ADDENDUM NO. 3**DATE: July 13, 2026**

PROJECT: HARMONY SCIENCE ACADEMY BRIDGELAND PHASE II MIDDLE-HIGH SCHOOL

**ARCHITECT'S PROJECT
NUMBER:** 06-22-014

The following addendum includes a change to the civil drawings and responses to bidders questions.

GRADING
PLAN (1 OF 4)

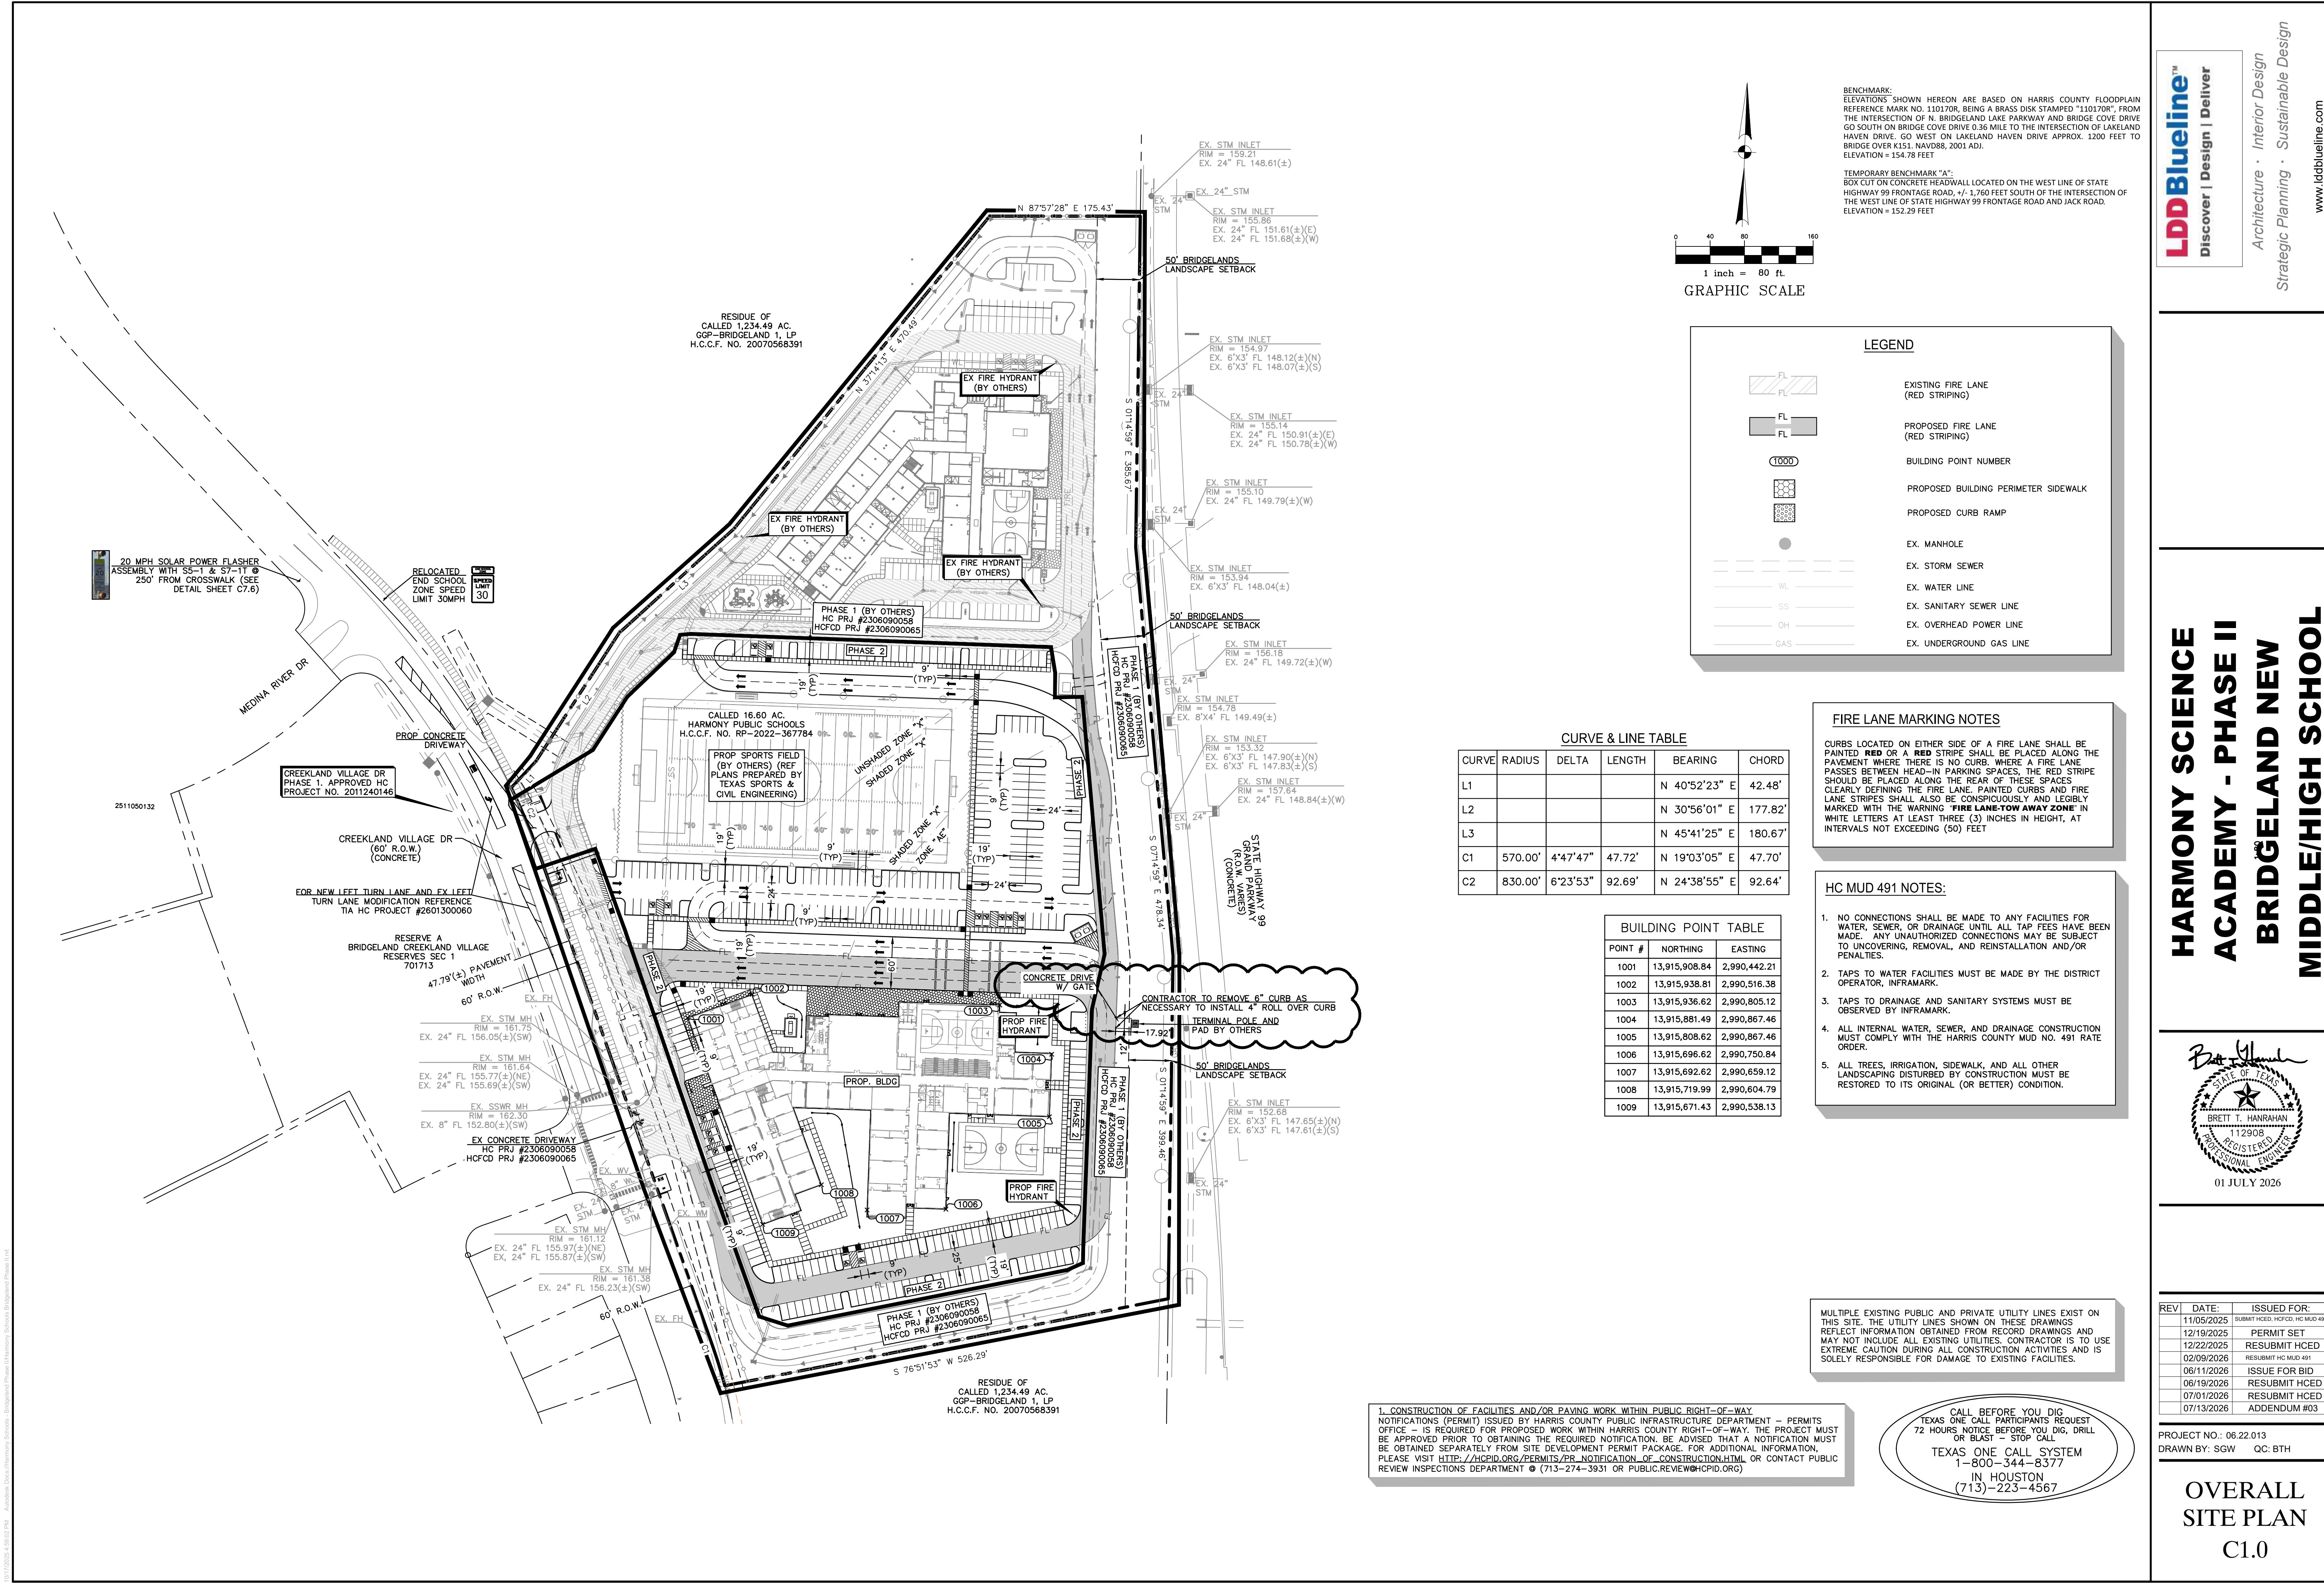
1. Drawing C1.0 –Overall Site Plan
 - a. **REVISE** Terminal Pole Pad
2. Drawing C4.0 Grading Plan (1 of 4):
 - a. **REVISE** Terminal Pole Pad
3. Drawing C4.1 Grading Plan (2 of 4):
 - a. **REVISE** Terminal Pole Pad
4. Drawing C5.1 Paving Plan (2 of 2):
 - a. **REVISE** Terminal Pole Pad
